**FIRE SAFETY FOLLOW UP INSPECTION**

| <b>Factory Name</b>            | Raidha Collections Ltd.                  |                               | <b>Accord ID</b>            | 11304 |
| <b>Address</b>                 | Habirbari, Zamirdia, Valuka, Mymensingh. |                               |                             |       |

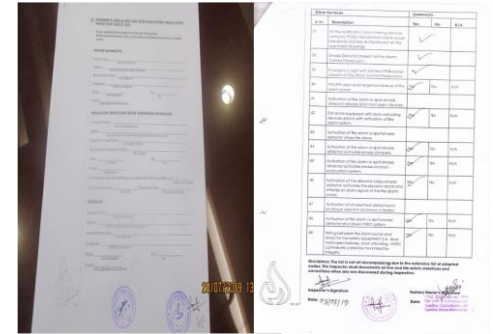
11 Inspection, testing, and maintenance of the fire alarm system is not in accordance with NFPA 72.

Inspect, test and maintain the fire alarm system, and keep written records on-site, in accordance with NFPA72.

On 22/02/16: It is an integrated part of fire alarm system.  
 On 26/04/16: It is an integrated part of fire alarm system.  
 On 22/08/2016: Corrected. Factory is maintaining a standard checklist as per code.  
 On 07/11/2016: Corrected.  
 On 10/01/2017: Corrected.  
 On 10.04.2017: Corrected.  
 On 20/07/2017: Corrected  
 On 14/Dec/2017: Corrected  
 18-07-2018: Corrected on previous follow-ups.  
 On 13/11/2018: Corrected  
 On 21/04/2019: Corrected. Maintaining.

On 28/07/2019: Corrected.

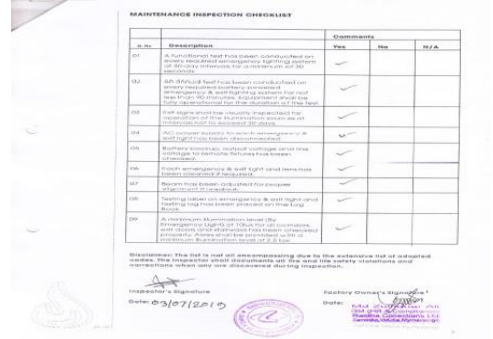
12 Inspection, testing, and maintenance for the emergency lighting system was not in accordance with The ACCORD standard.

Inspect, test and maintain the emergency lighting system in accordance with The ACCORD standard. Keep written records on site.

On 22/02/16: Completed  
 On 26/04/16: Corrected.  
 On 22/08/2016: Corrected. Factory is following a standard checklist as per code.  
 On 07/11/2016: Corrected.  
 On 10/01/2017: Corrected.  
 On 10.04.2017: Corrected.  
 On 20/07/2017: Corrected  
 On 14/Dec/2017: Corrected as per previous follow up.  
 18-07-2018: Corrected on previous follow-ups.  
 On 13/11/2018: Corrected  
 On 21/04/2019: Corrected. Maintaining.

On 28/07/2019: Corrected.
